RE: WPI Seg No. 256423 1/ FAP No. 3112-017P
U.S. 98 Noise Study Technical Memorandum

Project: **US 98 Dade City Bypass PD&E**
 Date: **April 18, 2002**
 Project No.: **15486**
 WPI Seg. No.: **256423 1**
 FAP No.: **3112-017P**

Air Quality Technical Memorandum

U.S. 98 DADE CITY BYPASS

Four-Lane Divided Urban Typical Section

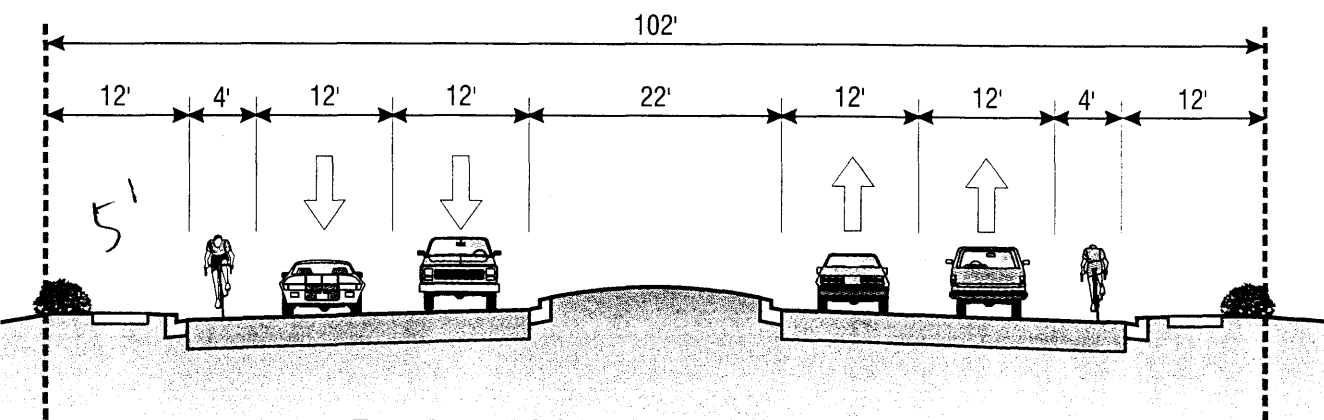
*Comments made
previously - Keep all
documents consistent.*
